**SUBDIVISION REVIEW SHEET****CASE NO.:** C8-2021-0090.0A**COMMISSION DATE:** December 21, 2021**SUBDIVISION NAME:** Maxwell Subdivision**ADDRESS:** 2114 Maxwell Lane**APPLICANT/AGENT:** Sergio Lozano-Sanchez, P.E. (LOC Consultants Civil Division, Inc.)**ZONING:** SF-3 (Family Residence)**NEIGHBORHOOD PLAN:** Montopolis**AREA:** 0.59 acres (25,700 sf)**LOTS:** 5**COUNTY:** Travis**DISTRICT:** 3**WATERSHED:** Carson Creek**JURISDICTION:** Full Purpose**VARIANCE:** None**DEPARTMENT COMMENTS:**

CITY OF AUSTIN –DEVELOPMENT SERVICES DEPARTMENT  
SUBDIVISION APPLICATION – MASTER COMMENT REPORT

**CASE NUMBER:** C8-2021-0090.0A  
**UPDATE:** U0  
**CASE MANAGER:** Juan Enriquez, Senior Planner [juan.enriquez@austintexas.gov](mailto:juan.enriquez@austintexas.gov)

**PROJECT NAME:** Maxwell Subdivision  
**LOCATION:** 2114 MAXWELL LN

FINAL PLAT  
MAXWELL SUBDIVISION

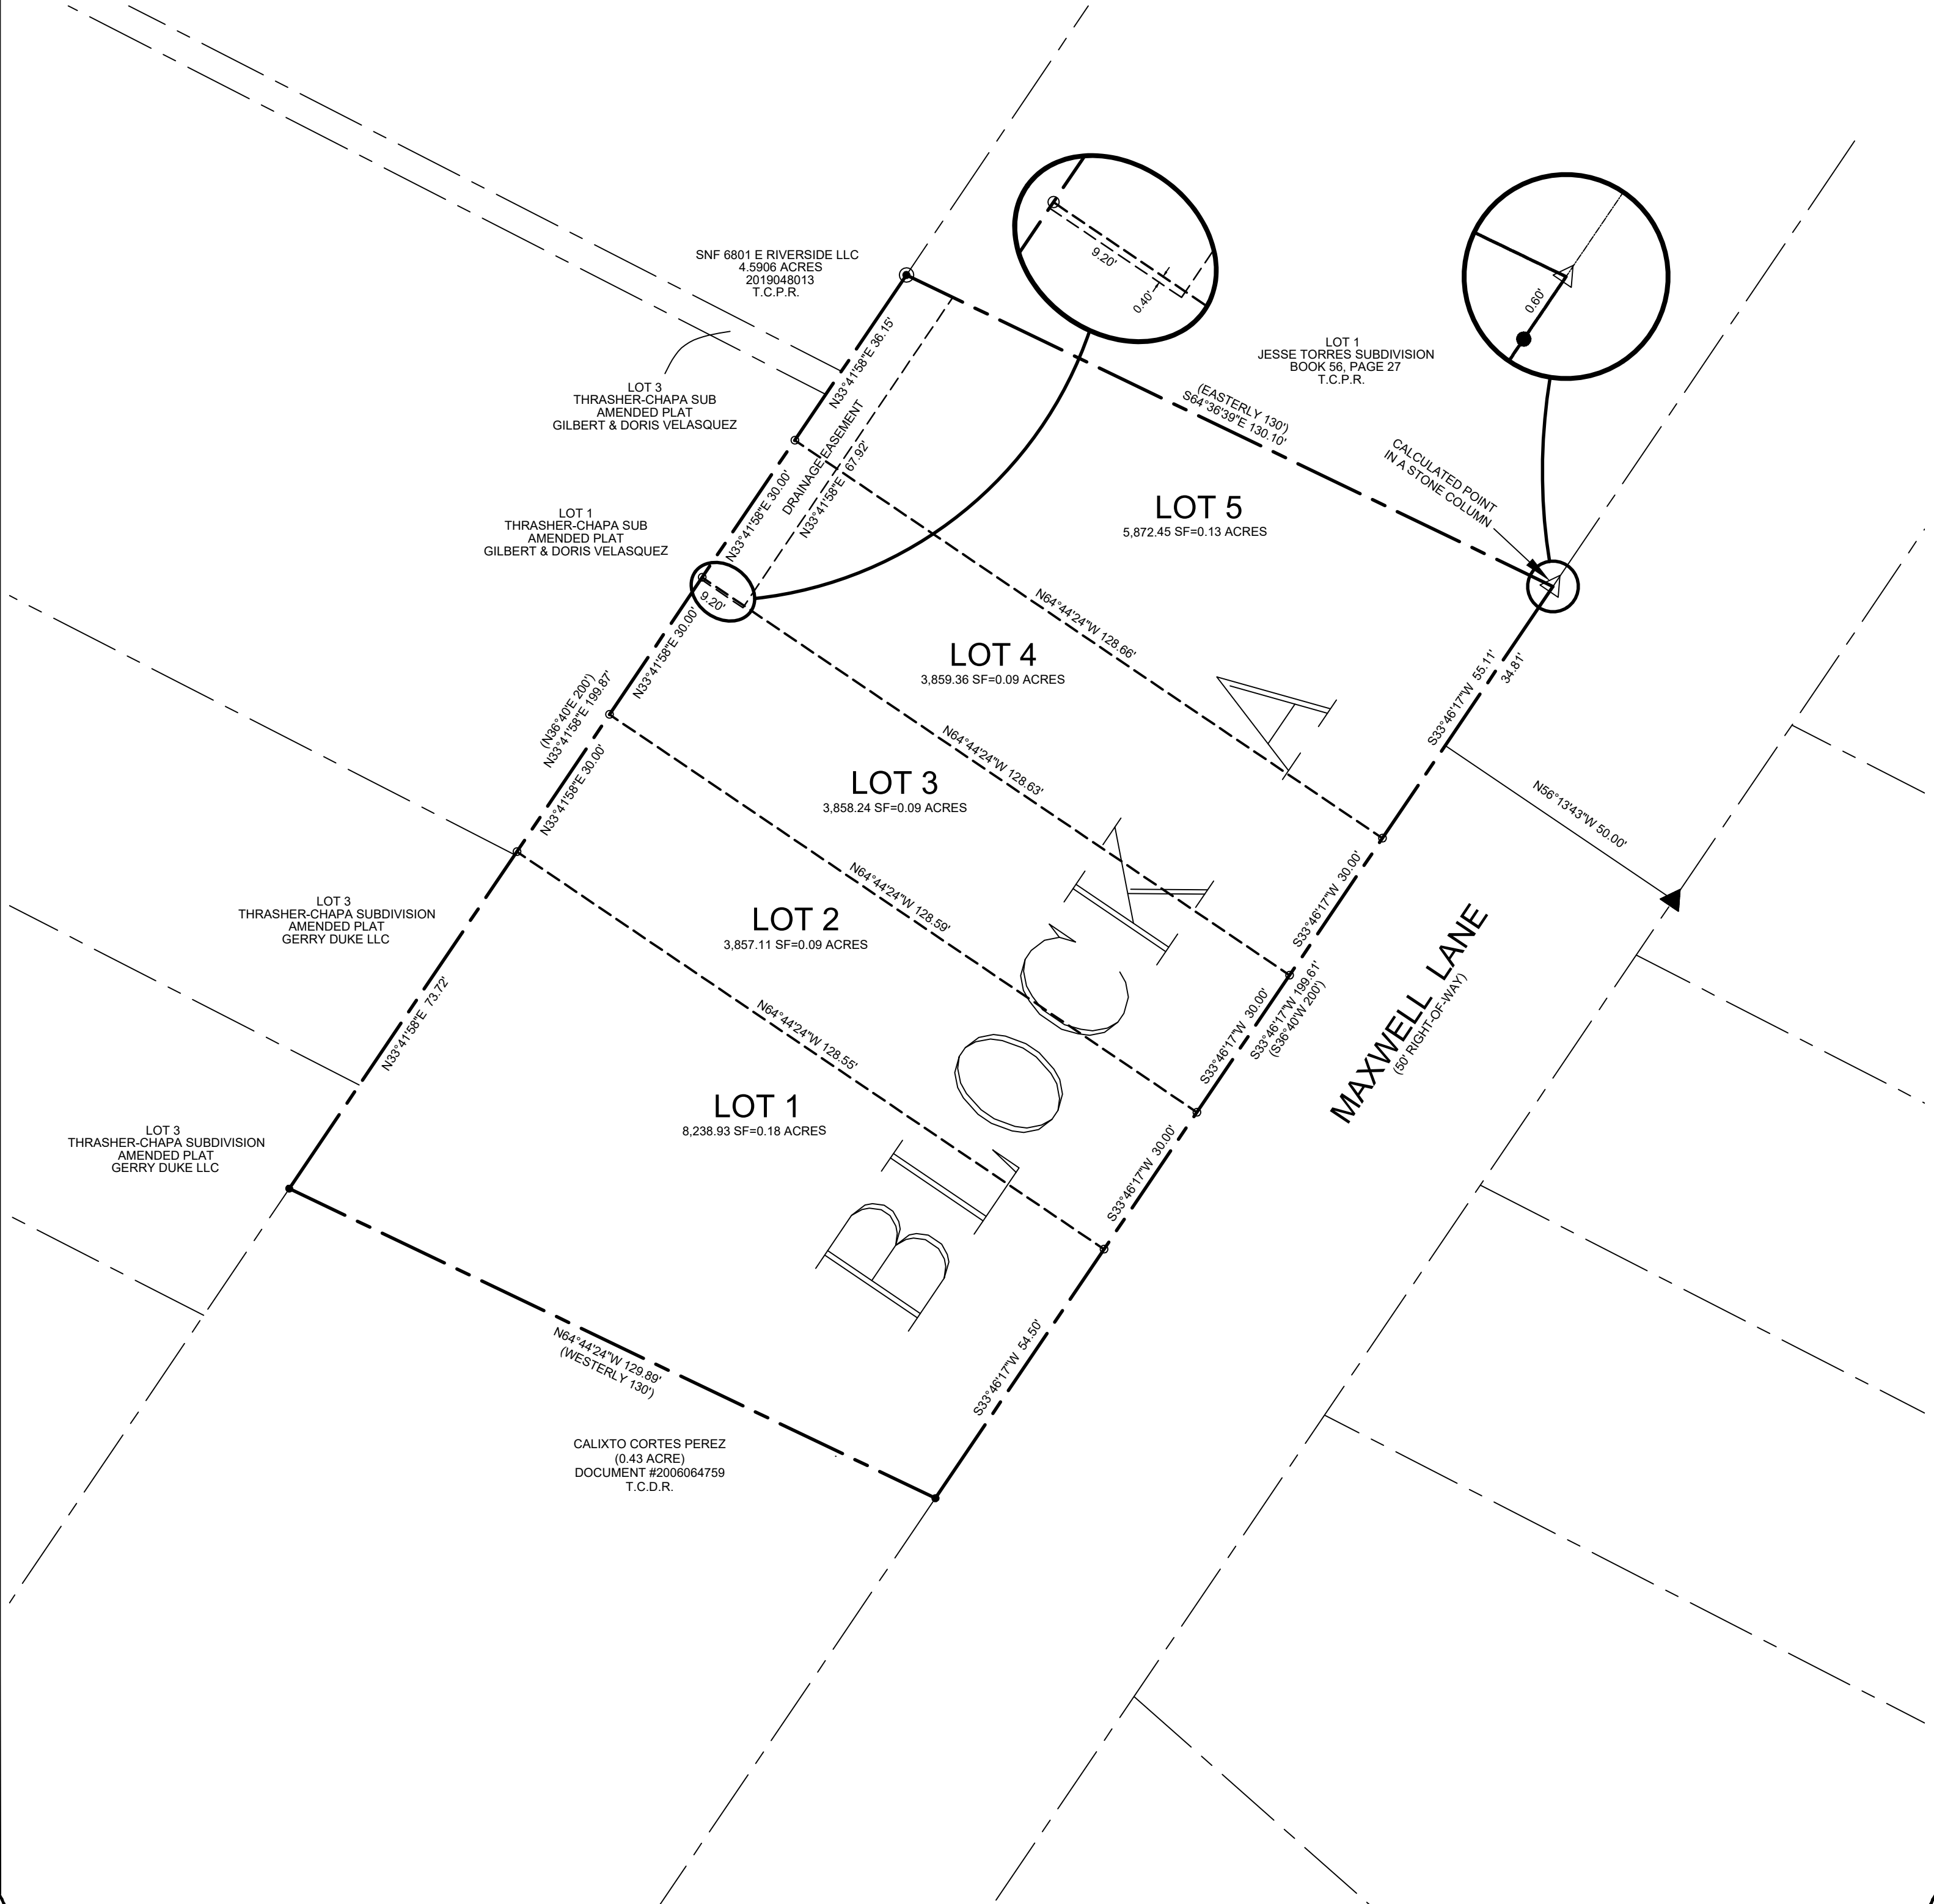
**Fifteen-foot electric distribution, electric telecommunications, and electric fiber easement is required adjacent to all street R.O.W. (Maxwell Ln).** Show the easement(s) on the face of the plat.

- ATD 1. The ASMP requires 60 feet of right-of-way for Maxwell Lane. Dedicate 30 feet of right-of-way from the existing centerline in accordance with the ASMP (LDC 25-6-55).
- ATD 2. Sidewalks are required on the subdivision side of Maxwell Lane. Identify the location of the sidewalks by a dotted line on the final plat and include the sidewalk symbol within the legend. LDC 25-6-351. TCM, 4.2.1.

- The boundary line must be solid and the heaviest weighted line.
- All proposed lot lines must be solid and the second heaviest line.
- Easement lines (existing and proposed) must be broken, and a lighter weight than lot lines. The easement area may be shaded or hatched.
- Lot lines outside but adjacent to the project must be broken and the lightest weight.

SR 13. Provide a lot summary table near the legend. Indicate the acreage of the overall subdivision, the size of each lot (in square footage, Lot 1, Lot 2, Lot 3, etc.), and the number and total of each land use (open space, drainage, parkland, etc.) Identify the cottage special use lots in the summary. Also label the "cottage special use lots" inside each lot for easy referencing. 25-1-83

SR 14. Remove the note on the top, left hand side of sheet 4 referencing single family residential. 25-1-83

SR 17. Expand the legend to include other line types shown in the plat. 25-1-83

SR 18. Show subdivision name and record reference, Volume \_\_\_\_\_, Page \_\_\_\_\_, or Doc# for adjacent platted property. Show owner's name and deed reference for adjacent unplatted property. Including the lots across the street on Maxwell Lane. 25-1-83
